Item Name: Crosstube Turning Detail

DART AEROSPACE LTD		Work Order:	96779
Description: Crosstube Assembly (412 Low Aft)		Part Number:	D412-664-249
Inspection Dwg: D412-664-249 Rev: B		Page 1 of 2

DRAWING NO. D412-664-249	TITLE CROSSTUBE ASS'Y (412 LOW AFT)	REV. B	DART AEROSPACE LTD ENGINEERING ORDER		D.E.O. NO. D412-664-249-B-1	SHEET NO. SHEET 1 OF 2	SCALE NTS
DRAWN 97	CHECKED SC	MFG. APPR. E	APPROVED MD		DE APPR. H		
DATE 11.05.25	DATE 11.05.31	DATE 11.05.31	DATE 11/05/31		DATE 11.05.31

**D412-664-249
ASSEMBLY DETAIL**

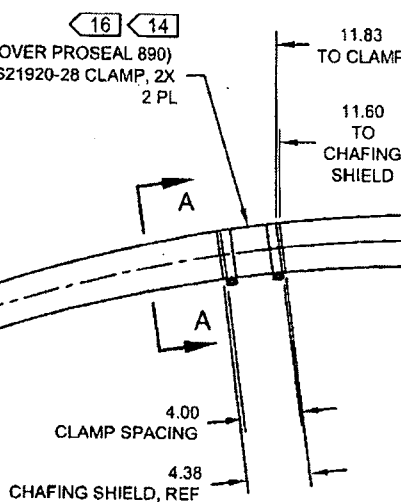
REMOVED ABRASION STRIP IN FAVOR OF A THIN LAYER OF PROSEAL 890. UPDATE INSTALLATION OF CHAFING SHIELDS AND REDUCE TORQUE TO 40-50 IN-LBS. THIS ENGINEERING ORDER SUPERCEDES DEO D412-664-249-B-1

D2856-600-1009 ABRASION STRIP
D3189-1 CHAFING SHIELD (1, INSTALLED OVER ABRASION STRIP)
MS21920-28 CLAMP, 2X
2 PL

D3189-1 CHAFING SHIELD (1, INSTALLED OVER PROSEAL 890)
MS21920-28 CLAMP, 2X
2 PL
